SERVICE BULLETIN

Date	14/06/04
Document n°	FRN-SB2004-05-introduction ECO function on A-class ovens-GB
Last Doc. n°	FRN-SB2004-04-Modification knobs_ front panel canali ovens-GB
Brand	Smeg - WW
Models involved	Multifunctional fan-operated 60cm ovens Series -5
Cause	Introduction of ECO functions on all ovens with Energy Class A
Description of modification	On all ovens with Energy Class A mounting commutator part nos. 811730270-0271-0272 , a new commutator part no. 811730302 is introduced. Consequently, the symbols on the front panel have changed in order to obtain 6 functions on all ovens, maintaining an ECO function (grill+bottom heating+fan) and introducing the convection+fan function (ceiling+bottom+fan).
Date of introduction	Starting from 23/04/04 and gradually on all models. To recognize immediately which commutator is mounted onto the appliance, look at the front panel.
Interchangeability	NO- on ovens with the old commutator, it is necessary to replace both commutator and front panel.

OLD CONFIGURATION

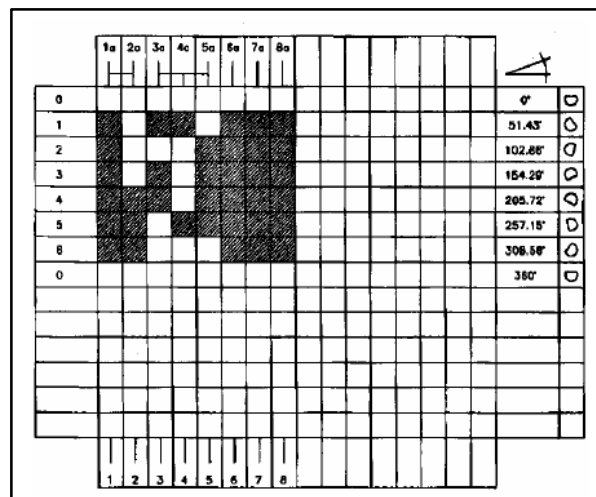
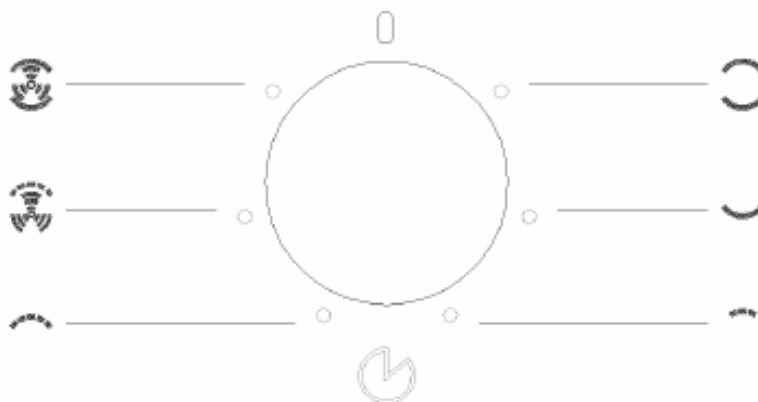
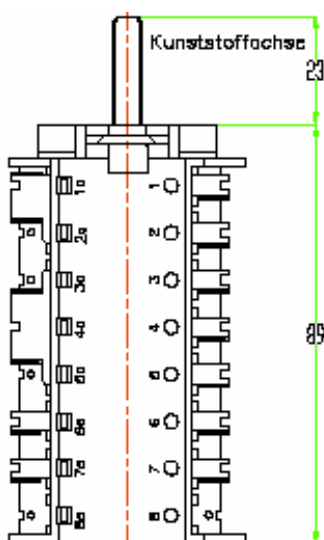
OLD COMMUTATOR COD. 811730271

OLD COMMUTATOR COD. 811730270

OLD COMMUTATOR COD. 811730272

OLD FRONT PANEL

to replace 811730271 with 811730302 : connect the pins serially, from contact 1 tot contact 6

to replace 811730270 with 811730302 : connect the pins serially, from contact 1 tot contact 6

to replace 811730272 with 811730302: connect the pins in the following way:

811730272		811730302
1-1a	⇒	1-1a
2-2a	⇒	2-2a
5-5a	⇒	3-3a
6-6a	⇒	4-4a
7-7a	⇒	5-5a
9-9a	⇒	6-6a

Two contacts on the commutator 811730302 remain free.

NEW CONFIGURATION

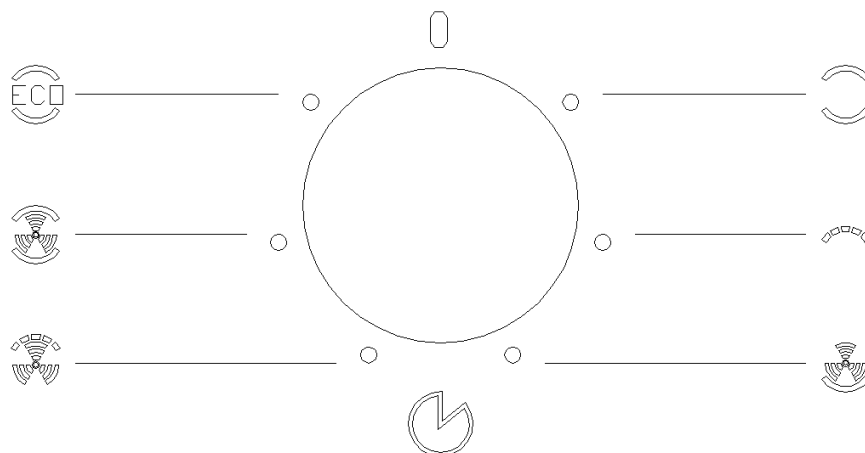
NEW COMMUTATOR 811730302

NEW FRONT PANEL
